**ITB 14-02  
2014 Street Resurfacing  
Addendum II  
Issued May 23, 2014**

**Appendix D – Speed Table Construction**

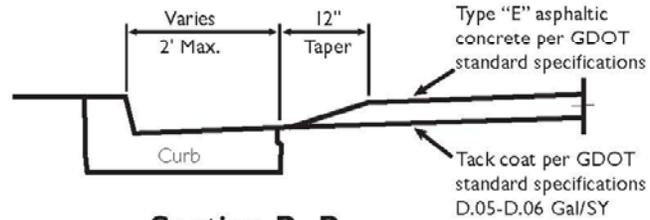
- 4) Could the City of Brookhaven provide a detail for the Speed Humps?  
*See attached detail*
- 5) Are the curb replacement areas marked on W. Nancy Creek Dr.?  
*Areas are not currently marked, but it is intended to replace the broken curb and gutter around the traffic islands and on the outside at the traffic islands. A Pay item has been added to the revised Bid Schedule for this item.*

1. Speed humps may only be placed on streets with grades less than 8%
2. Speed humps shall be installed on "two-pass" streets only to ensure residential traffic only will traverse them

Taper shall be 6" for road widths of 22" or less

# DETAIL 03410-09 COBB COUNTY WATER SYSTEM MANHOLE ADJUSTMENT IN PAVEMENT

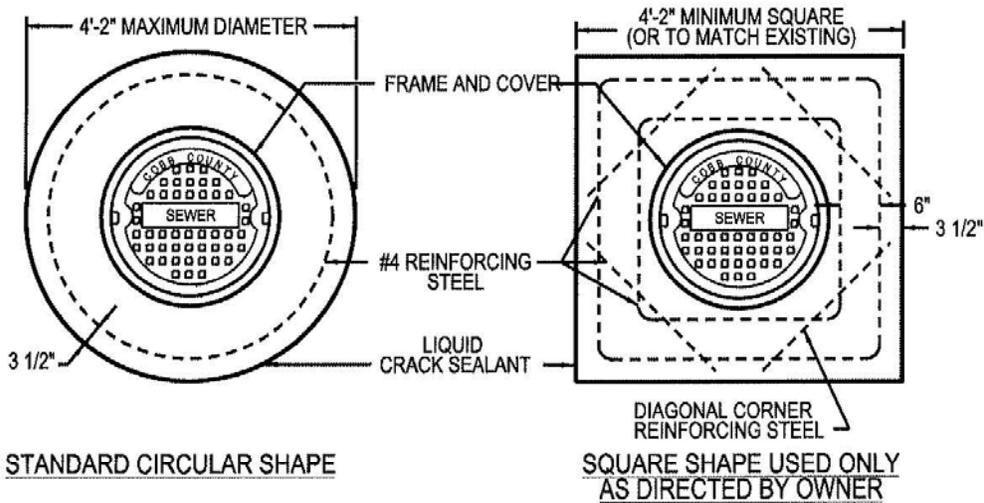
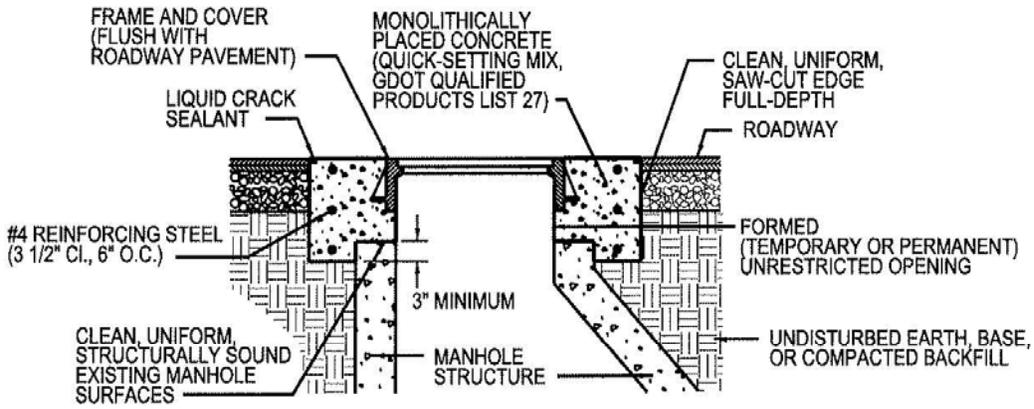
- 3) The proposal states that there will be details provided for the manhole adjustments. There are not any details in the proposal. Please advise.  
*See attached detail.*

IF REPLACEMENT OF THE FRAME & COVER IS NECESSARY, ACCEPTABLE PRODUCTS ARE EAST JORDAN IRON WORKS V-1480-1, V-2480, V-2480-1, OR U.S. FOUNDRY 360E OR 360E/WT AS REQUIRED BY FIELD CONDITIONS OR DIRECTED BY OWNER.
